SUBJECT: MONTICELLO NUCLEAR GENERATING PLANT - ISSUANCE OF AMENDMENT
RE: EXTENDED FLOW WINDOW (CAC NO. MF5002)

The amendment revises the Technical Specifications (TSs) and Renewed Facility Operating License to allow operation in the extended flow window (EFW) domain.

Amendment No. 191
License No. DPR-22

Figure 5 – MNGP CIER and EFWS regions

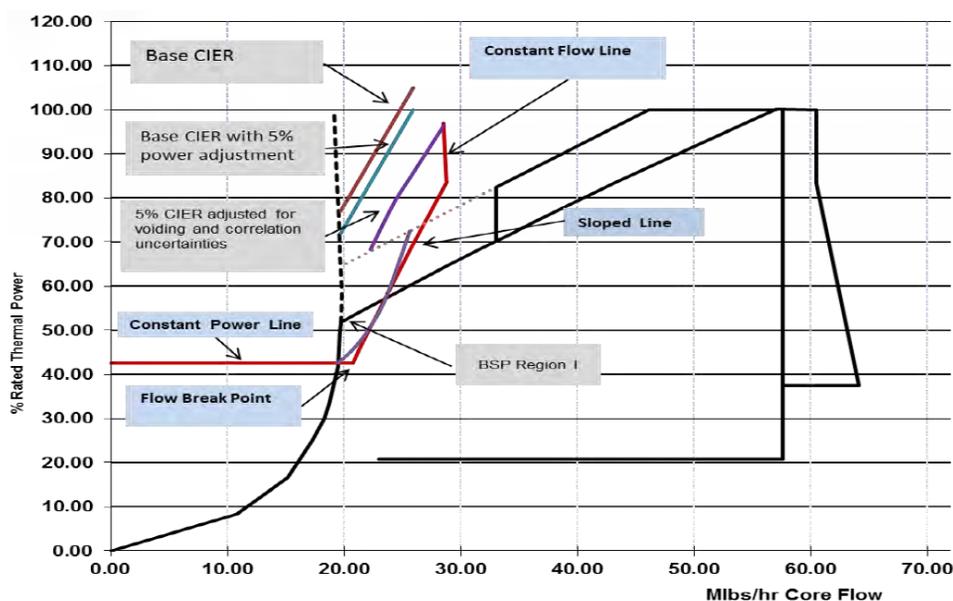
MNGP has provided sample calculations for the CIER and EFWS regions. Because of the low power density and relatively large inlet orifice pressure drop, MNGP is a relatively stable plant and the CIER lies completely outside the operating map, as shown in Figure 5. Note that this

calculation is performed on a cycle-specific basis and this region may change in future cycles, but it is not likely to vary significantly.

The EO-III SER for ANP-10262(P)(A) did not specifically endorse a backup stability solution; instead, it required a plant specific review of the proposed implementation. MNGP has proposed to use a single exclusion region (the EFWS) to enforce both the CIER when the PBDA algorithm is enabled, and the backup stability protection (BSP) regions. For this reason, only one EFWS region is defined, and it corresponds to the red line in Figure 5. It is defined with three straight lines: constant power, constant drive flow lines and a straight line connecting them. The red line is defined to encompass the entire calculated BSP region.

Figure 19 – Axial core-average void fraction in Monticello versus a high-power-density BWR6

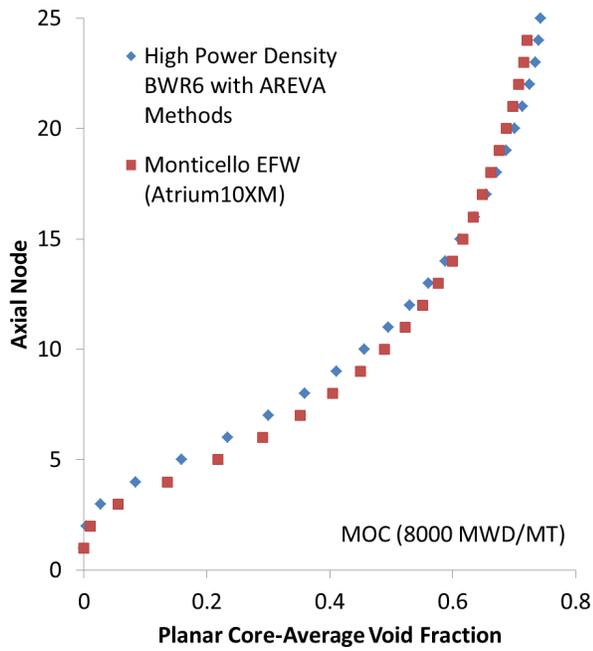
Figure 19 shows a comparison of the axial distribution of the core-average void fraction for a high-power-density BWR6 that uses AREVA methods and MNGP at the 100 percent power and 80 percent core flow corner. Figure 20 shows a composite of the core exit void fraction for all the channels in the core. Figure 21 shows a comparison of flow and exit quality for Monticello operating conditions (yellow points) and other reactors in the fleet (blue points) along with the test points from the KATHY tests (red – void fraction, and magenta – delta-P). A comparison of the above results indicates that the operating reactor fleet operating conditions bound the expected operation in MNGP.
